TRANSMITTAL LETTER FOR SERVICE BULLETIN NMD-52-12

DOORS — ENTRANCE — UTILITY STEPS (CO G100) — REINFORCEMENT (Mod N732)

NMD-52-12

DOORS — ENTRANCE — UTILITY STEPS (CO G100) — REINFORCEMENT (Mod N732)

Figure 1 Utility Steps (CO G100) Pre Mod N732

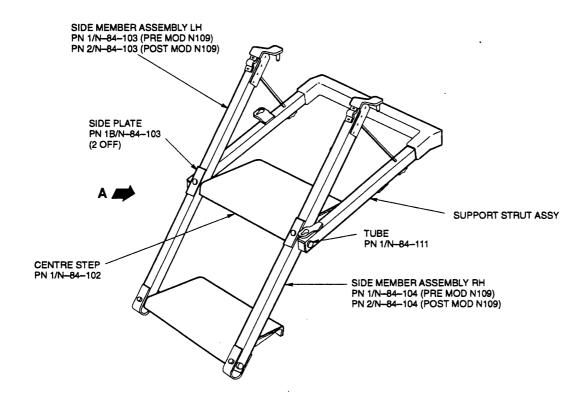
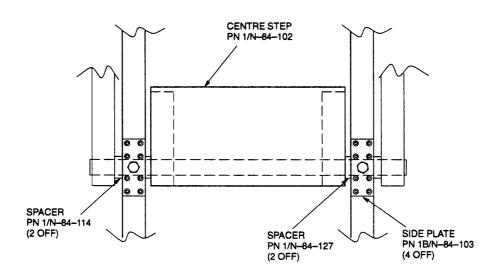
The existing side plates on the side member assemblies are replaced by two reinforcing plates and two angles.

- (1) Derivet centre step PN 1/N-84-102 (Ref Fig 1). Support tube PN 1/N-84-111 and punch out two pins PN 1/N-84-113. Discard pins.
- (2) Grind off the peened end of the two bolts securing tube PN 1/N-84-111. Remove nuts, washers and bolts and scrap. Withdraw tube completely.
- (3) Scrap spacers PN 1/N-84-114 (2-off) and PN 1/N-84-127 (2 off). Derivet and remove four side plates PN 1B/N-84-103 from the LH and RH side members (Ref Fig 1). Punch out rivet tails from the side members. Scrap side plates.
